BID ADDENDUM 4 – DSA ADDENDUM NO. 11 DATE: 10/16/2026

PROJECT:
SANGER EDUCATION COMPLEX – PHASE 3b
Development of Building L, associated site development work and Alternate Bid 1
1850 S. Fowler Ave, Fresno, CA 93727

DARDEN PROJECT NO. 2171.L
DSA APPL. NO. 02-120779

SD/A016
AD11

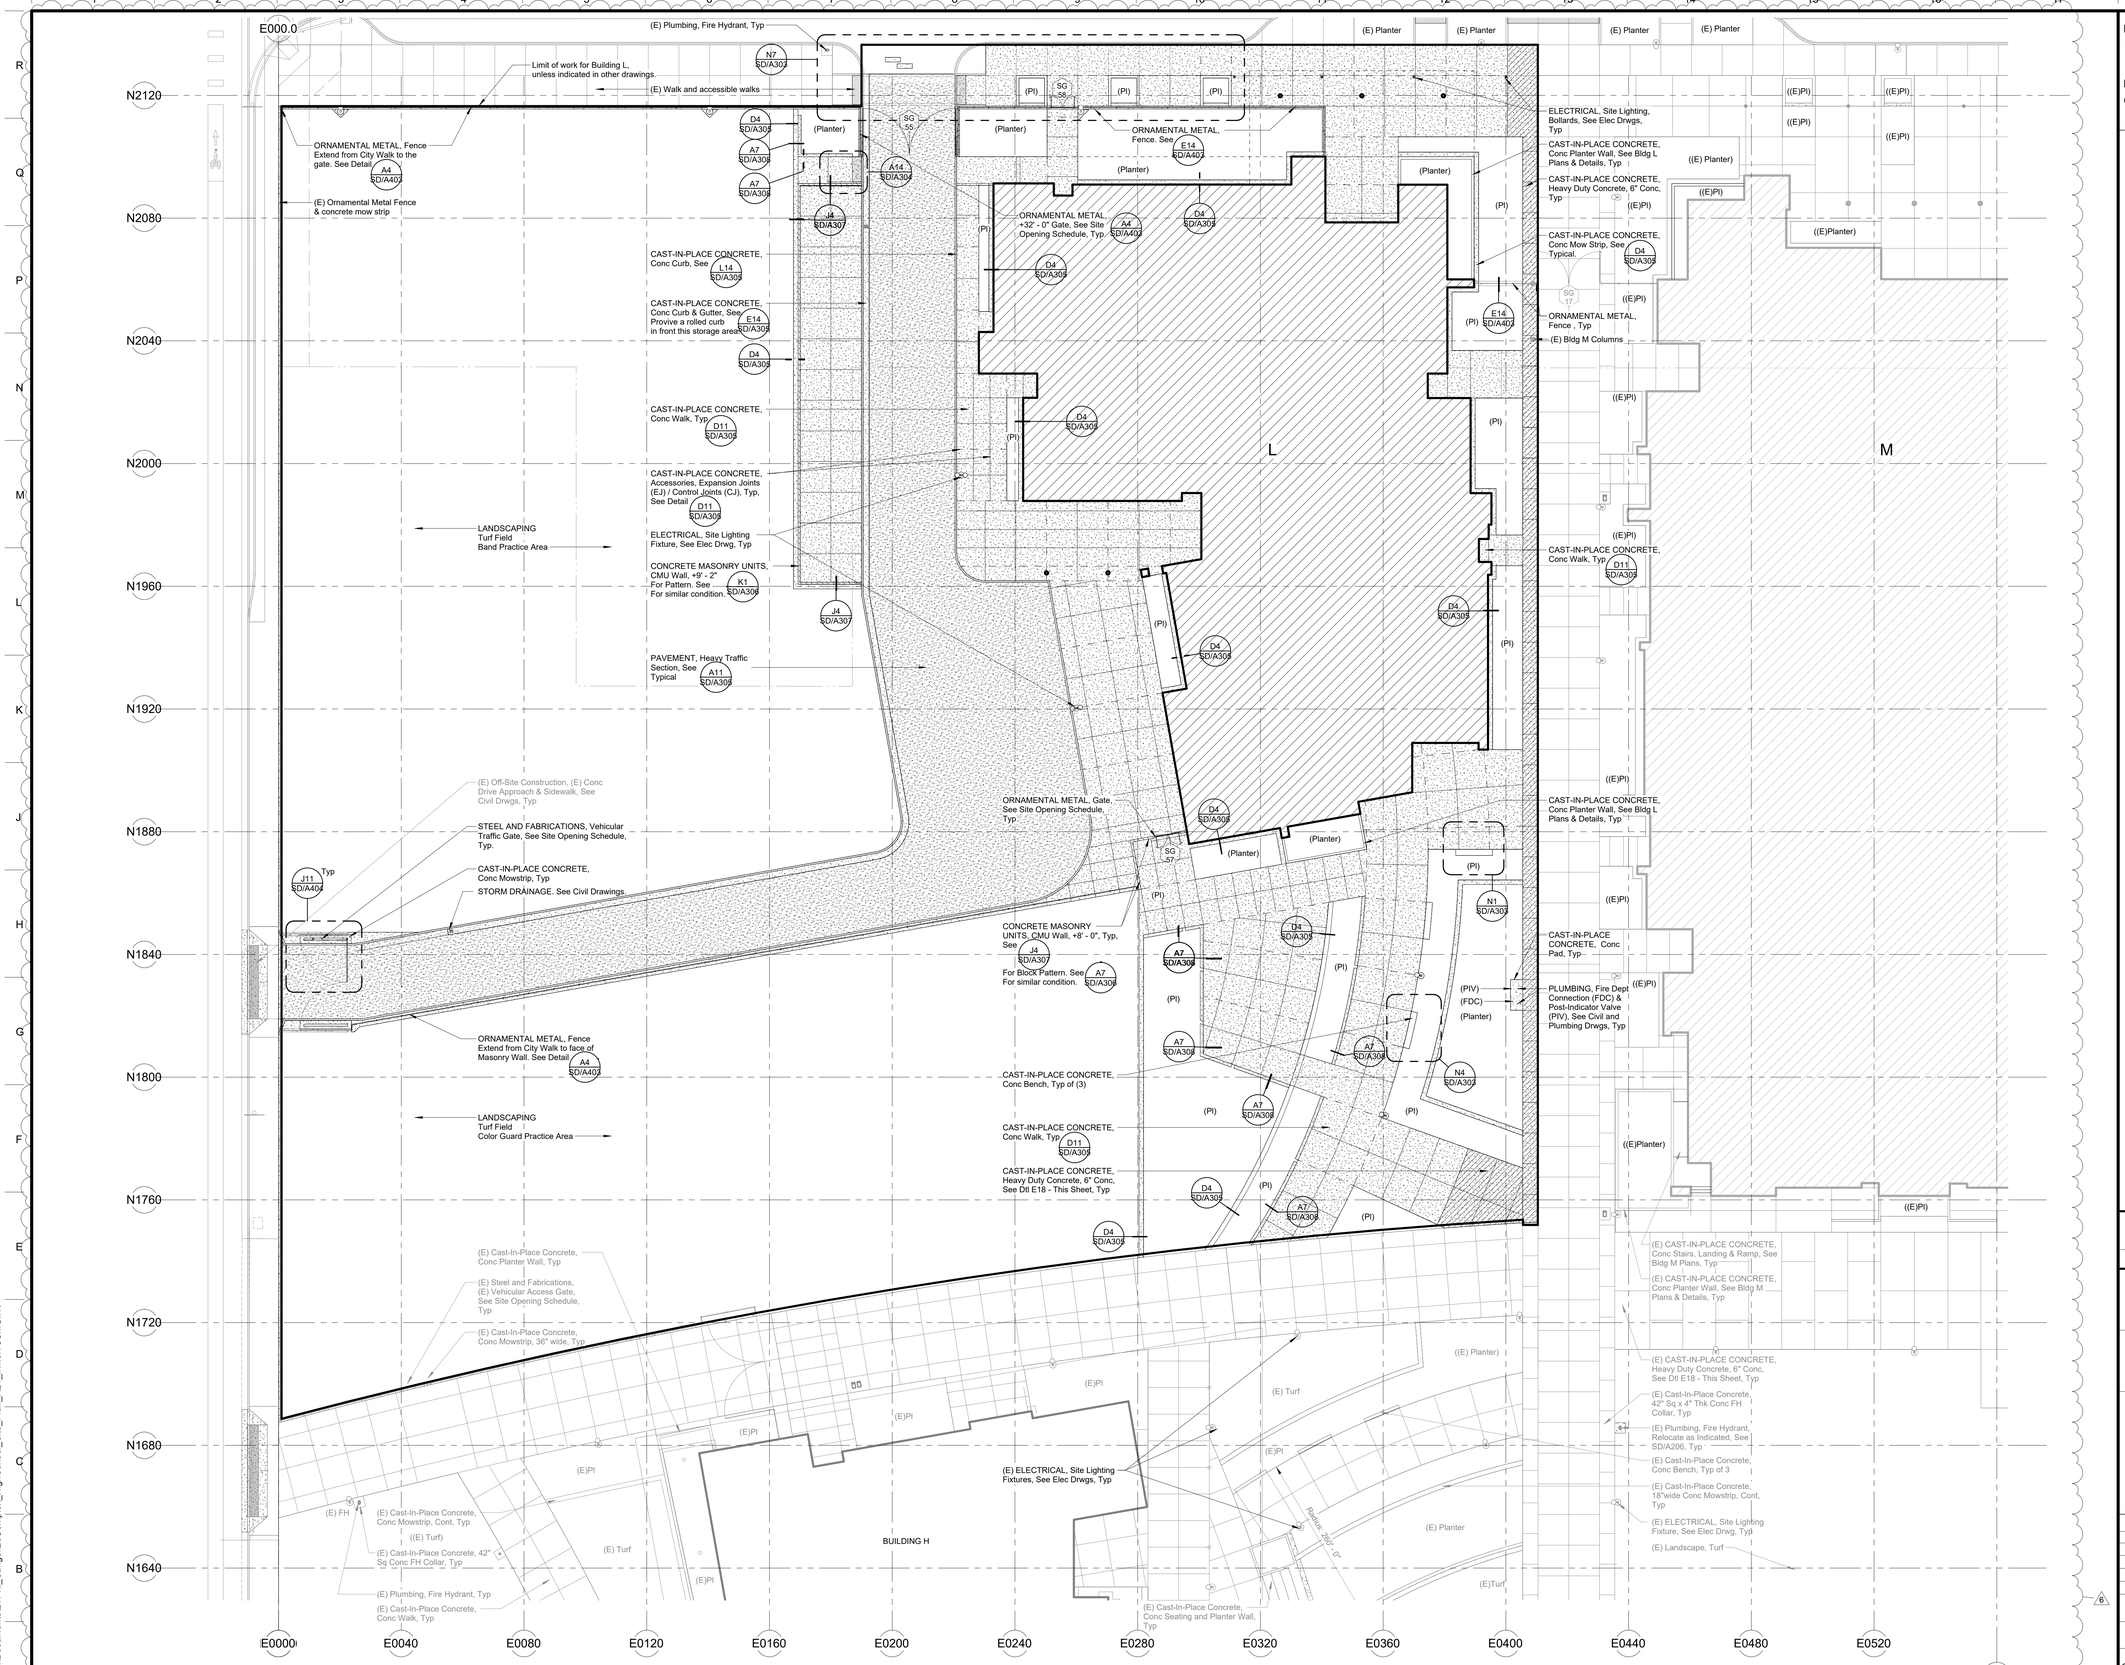
AD11-A01 Refer to Sheet SD/A016 – Partial Site Demolition Plan:

1. Add the attached new Sheet SD/A016 – SITE DEVELOPMENT, PARTIAL SITE DEMOLITION PLAN, identified as DSA Addendum No. 11, to the Contract Documents.
2. Sheet SD/A016 indicates the selective demolition within and adjacent to the Building L limit of work, including removal of concrete walks and curbs, and the removal and reinstallation of one (1) existing site light. Refer to AD11-E05.

L/A202.4
AD11

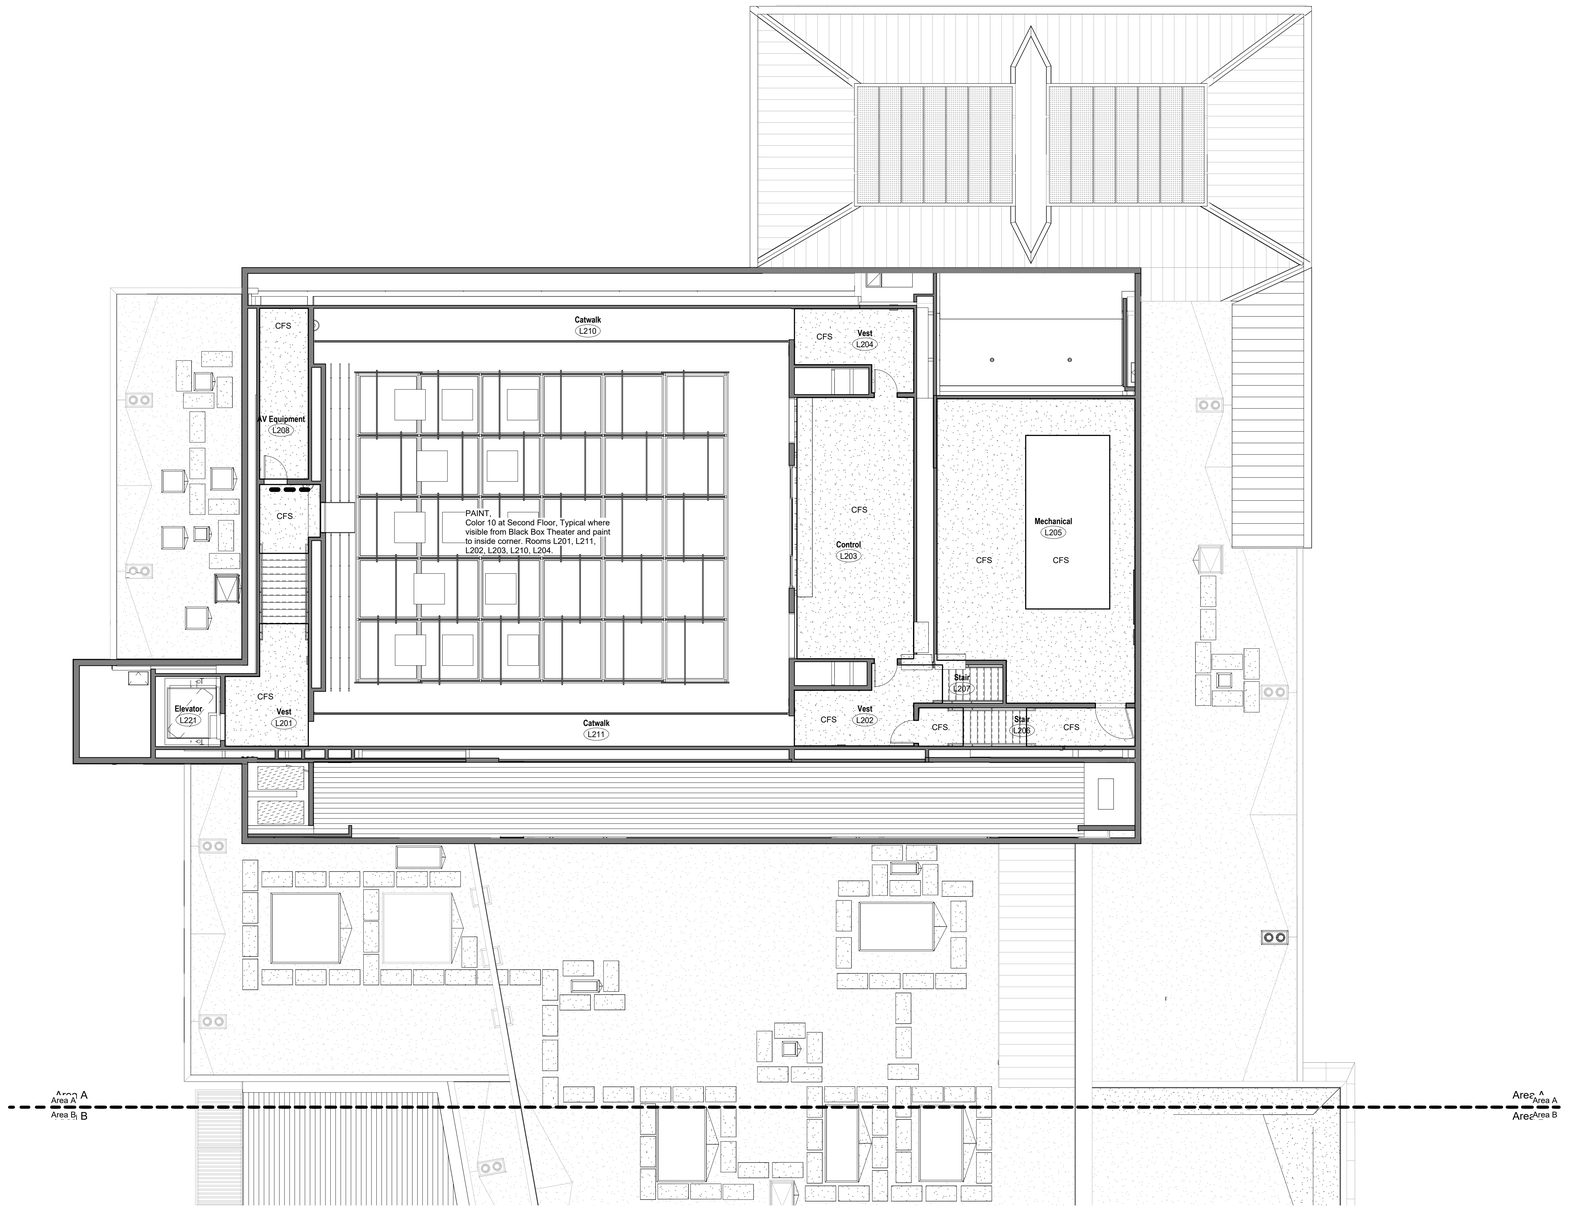
AD11-A09 Refer to Sheet L/A202.4:

2. Changes are clouded and identified with Delta 11.
3. The soffit lights shown on the electrical plans are now indicated on the architectural ceiling plan.
4. The soffit vents between the lights have been added.

L/F201-

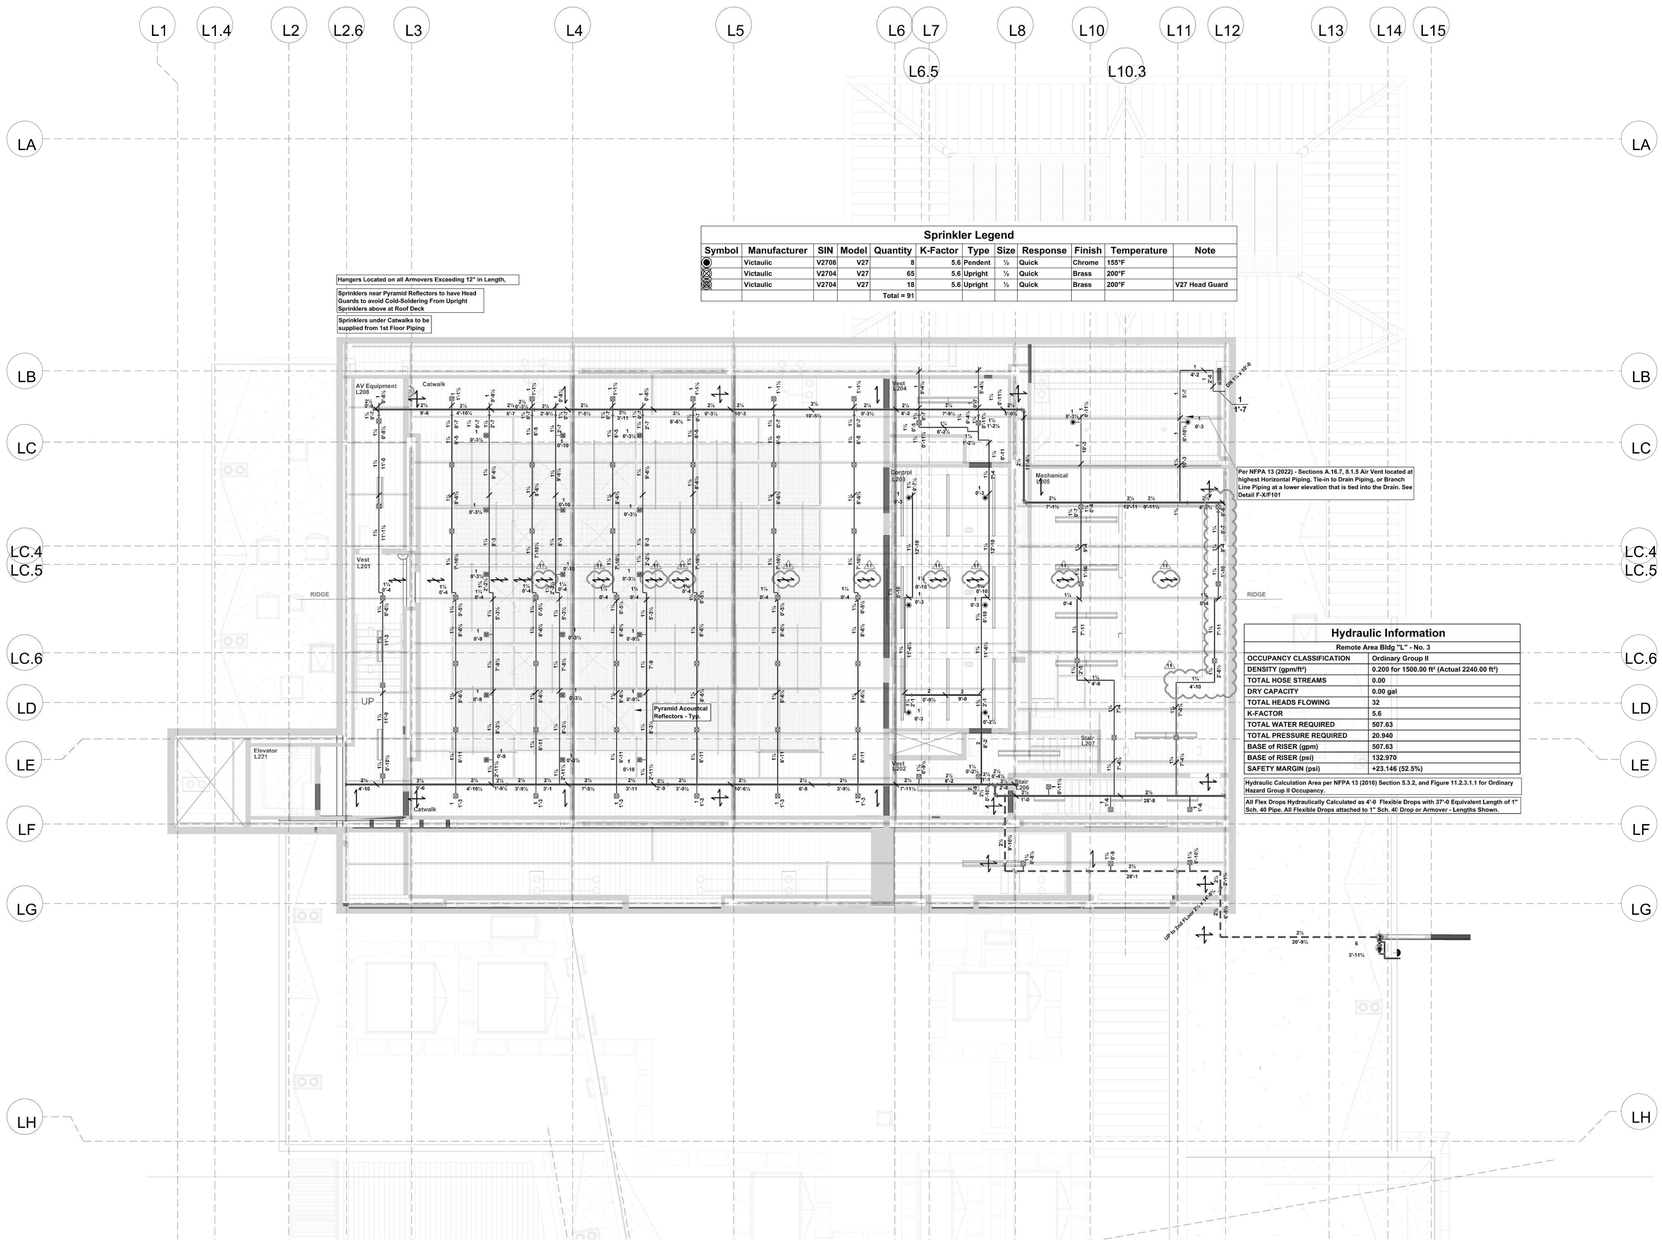
AD11-FP04 Refer to Sheet L/F201:

1. Omit Sheet L/F201 and replace with the attached Sheet L/F201, identified as DSA Addendum No. 11.
2. Changes are clouded and identified with Delta 11.
3. Level 2: (10) end-of-line branch line restraints have been added to the branch lines.
4. The branch line under the Roof Equipment Door in Mechanical Room L205 has been revised so that it does not obstruct the clearances required under the door.

L/P101.4
AD11

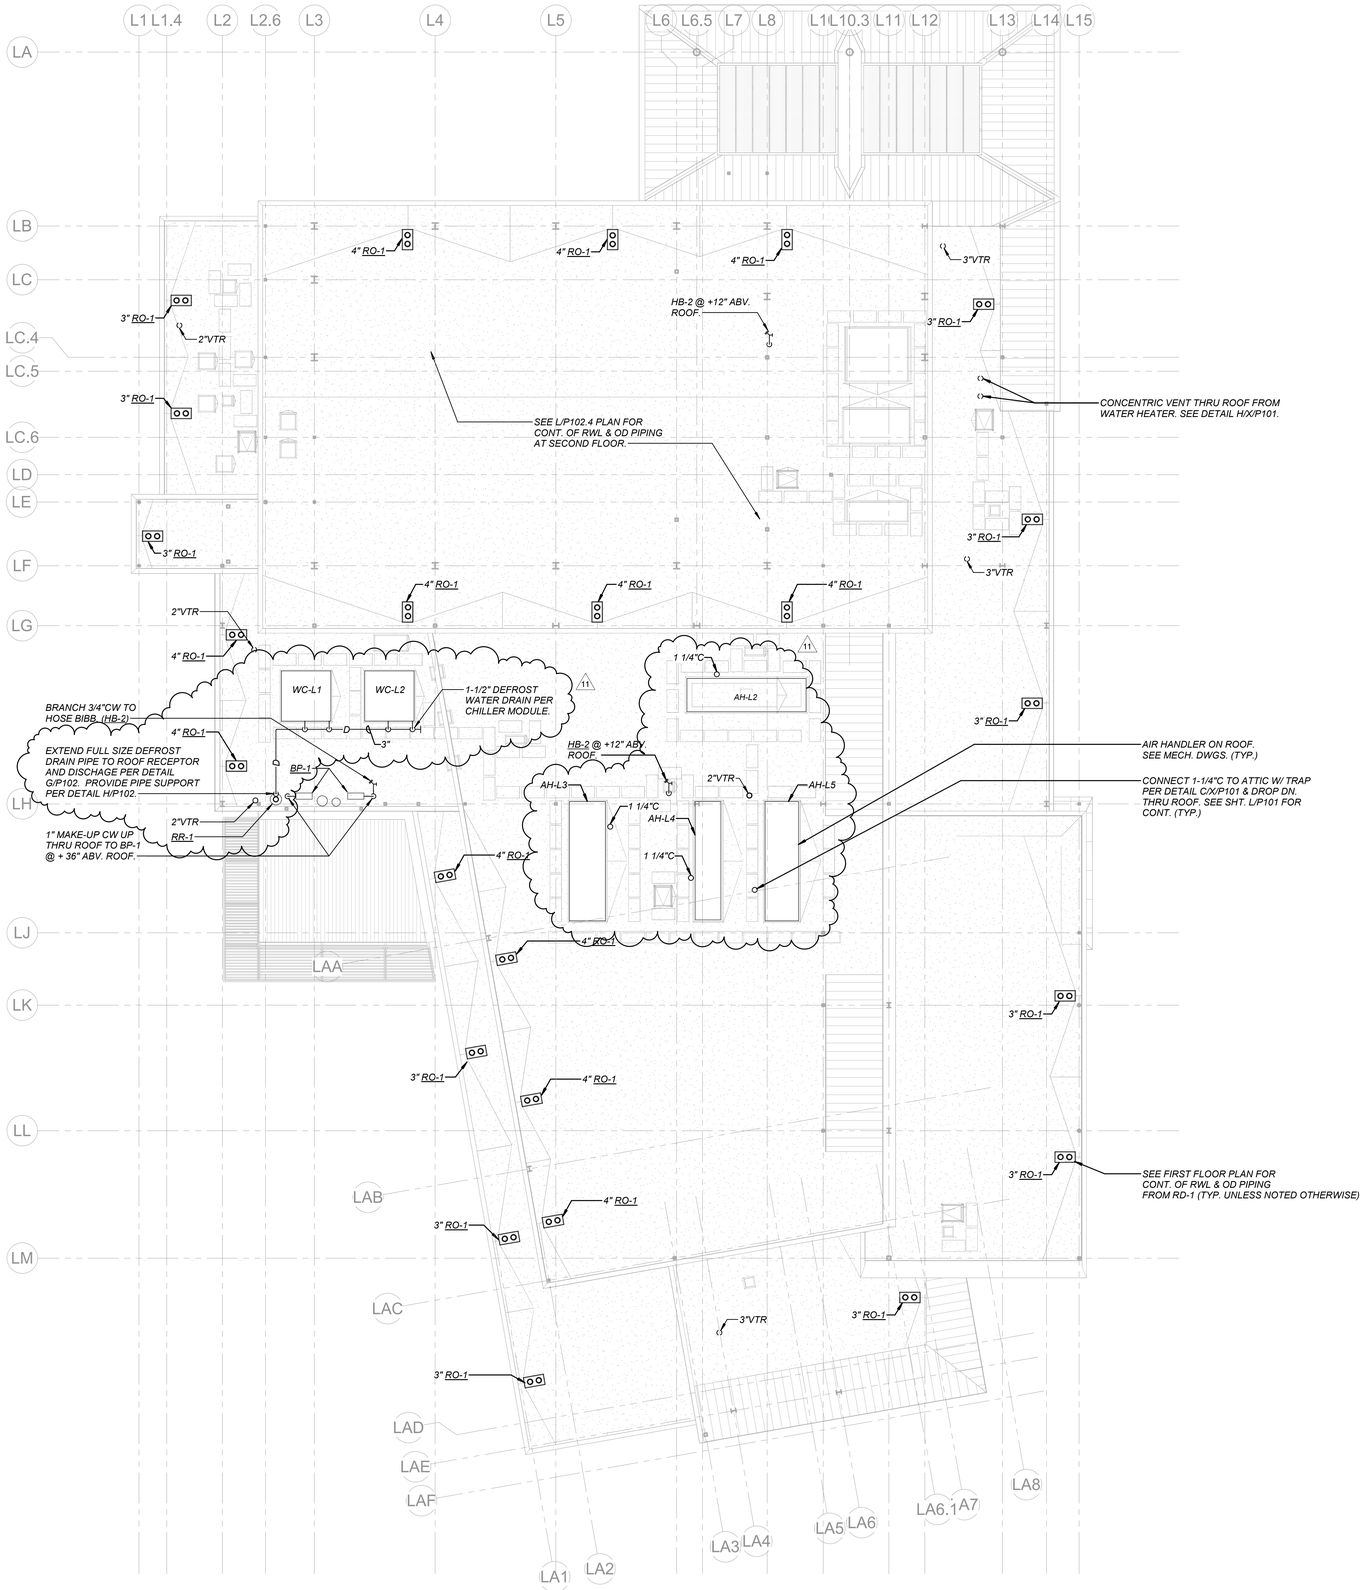
AD11-P04 Refer to Sheet L/P101.4:

1. Omit Sheet L/P101.4 and replace with the attached Sheet L/P101.4 per revision Delta 11 dated 10/16/26.
